**FINAL DRAINAGE REPORT ADDENDUM #1
FOR
PLATTE SELF STORAGE
COLORADO SPRINGS, COLORADO**

OCTOBER 2025

TNE Job No. 2419.00
County Job No. PPR2418

The purpose of this Final Drainage Report Addendum #3 for Platte Self Storage is to show the changes to the proposed drainage conditions from regrading the site.

PLATTE SELF STORAGE
PROPOSED DRAINAGE MAP

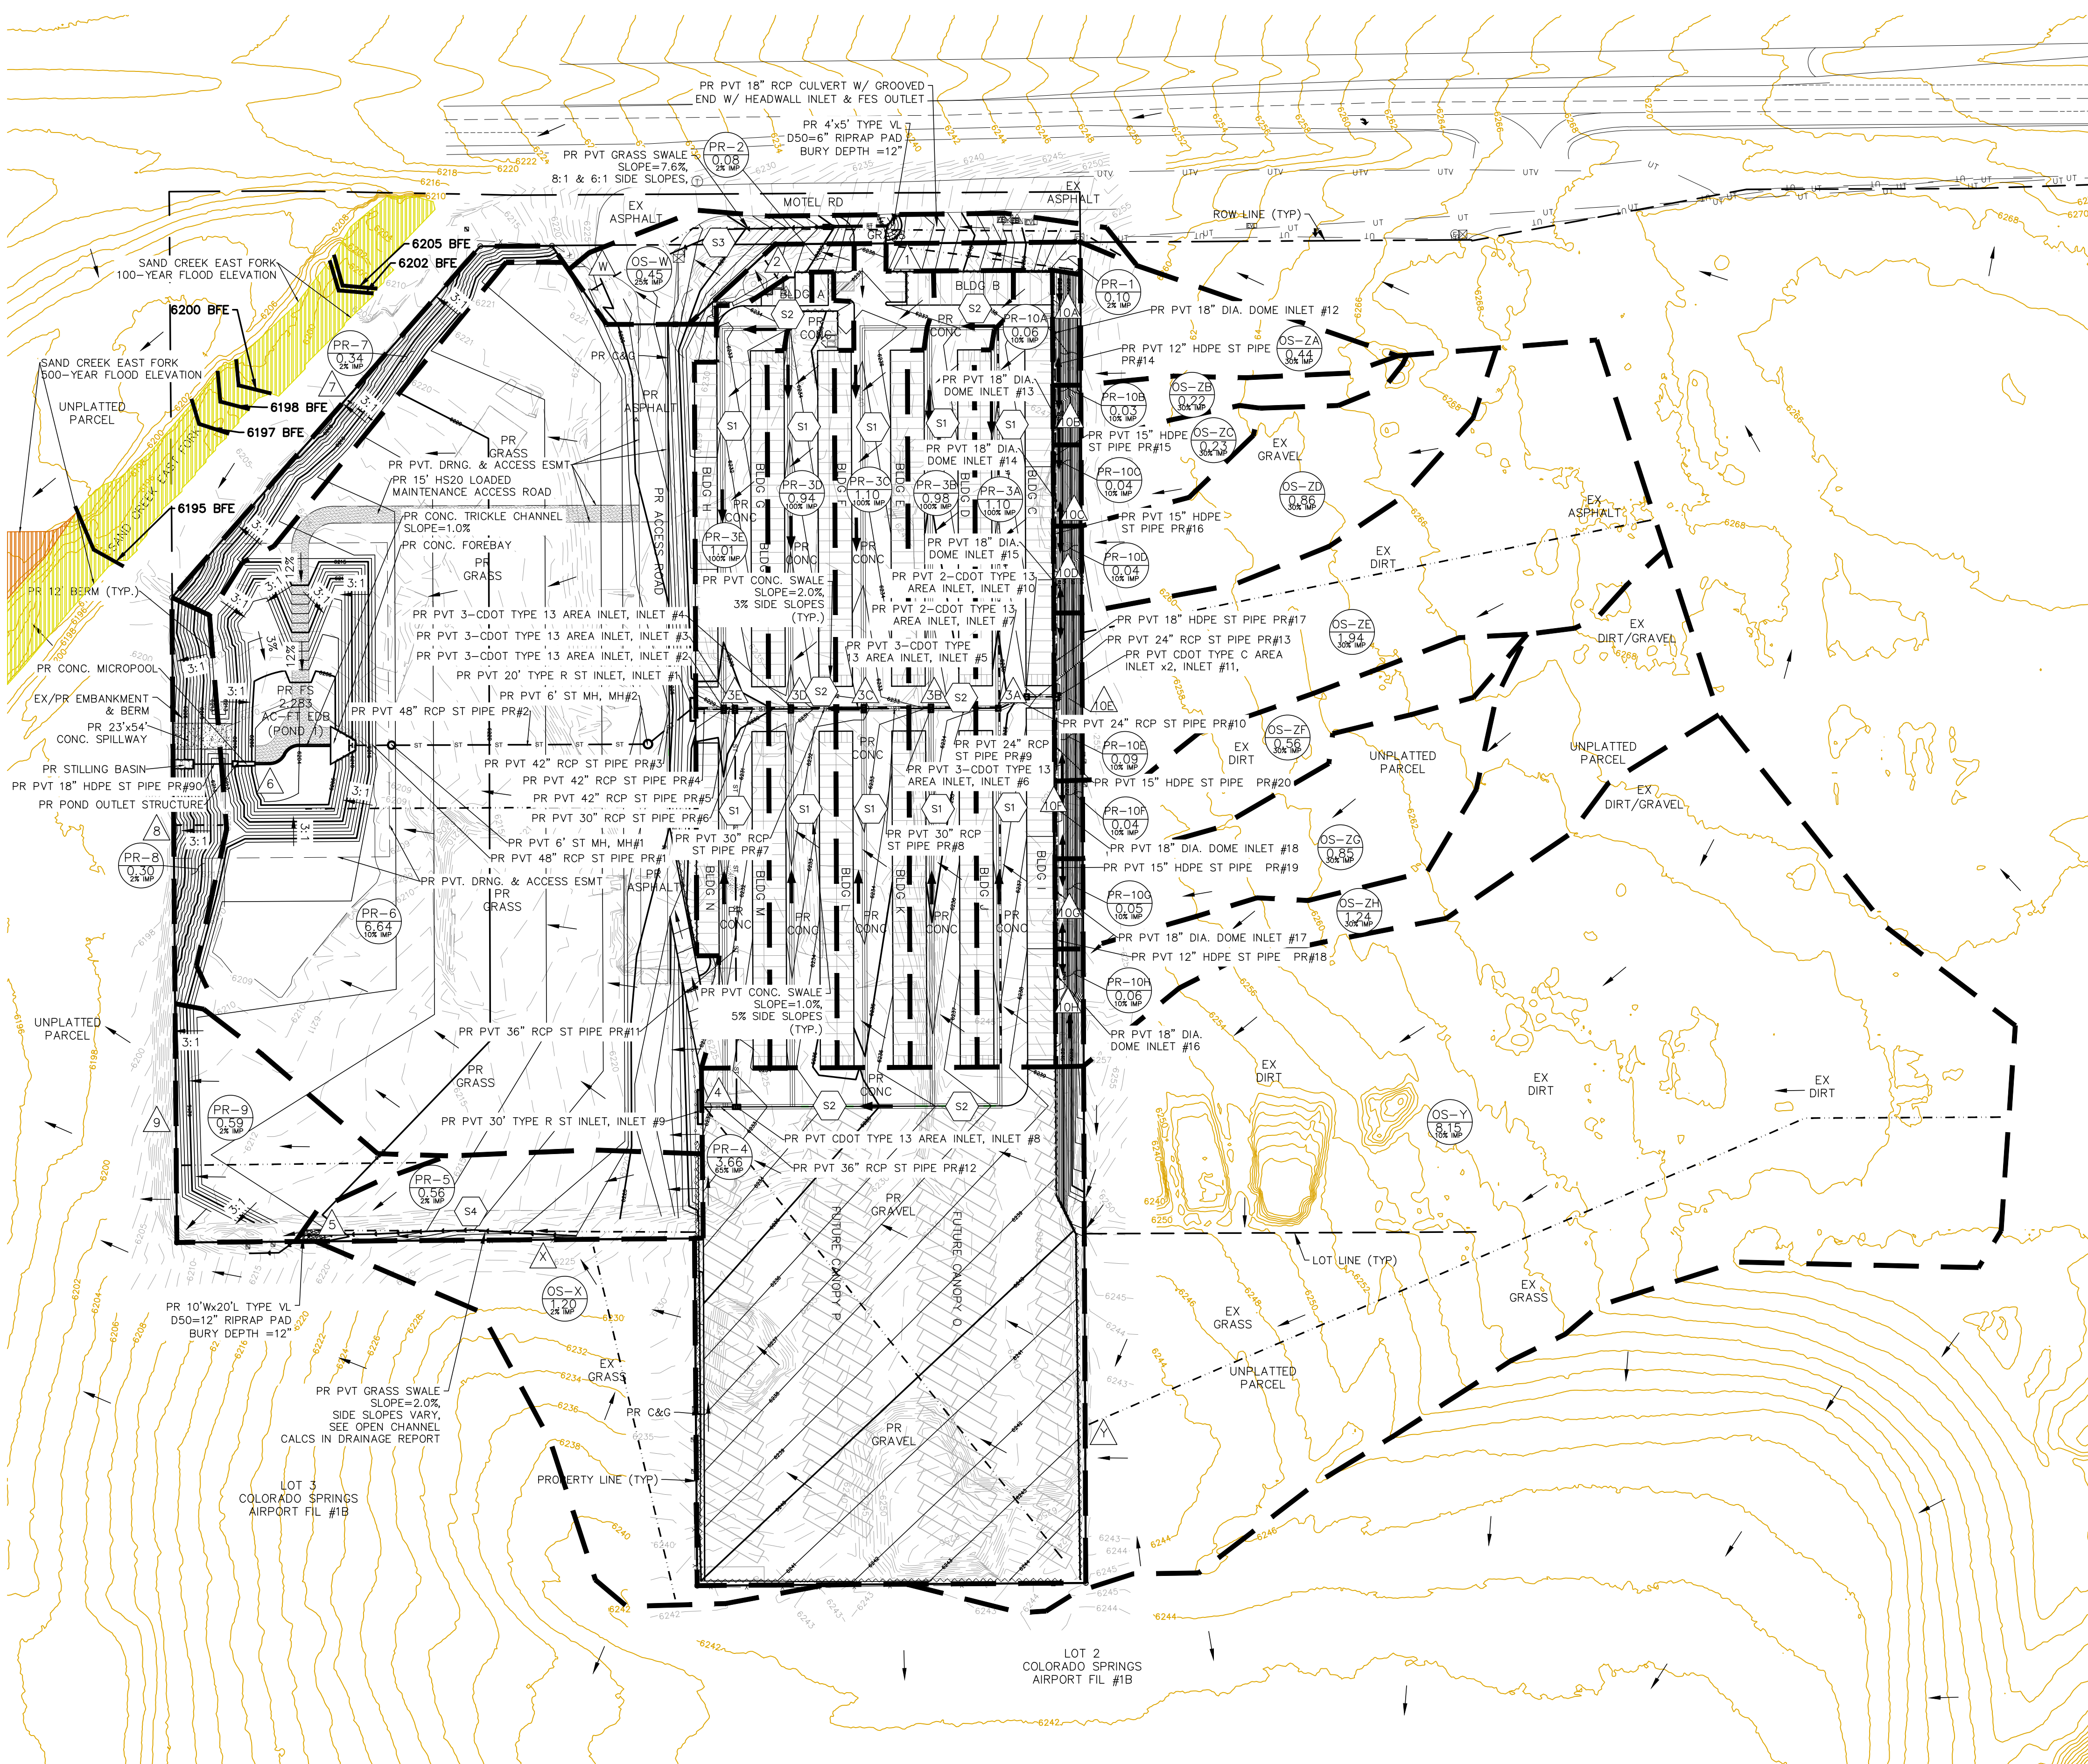
The site grading was changed to alter earthwork requirements. This resulted in lowering the east half of the site and changing embankment locations on the west half of the site. The driveway to the mini-storage area was moved as a result and the adjacent buildings have changed. Overall, the drainage patterns for the site remain similar, with small changes to some basin boundaries. Many of the storm pipe elevations were lowered, while the pattern of storm pipes remains the same. The stormwater pond remains the same.

The grading changes affect proposed basins PR-1, PR-2, PR-3B, PR-3C, and PR-3D.
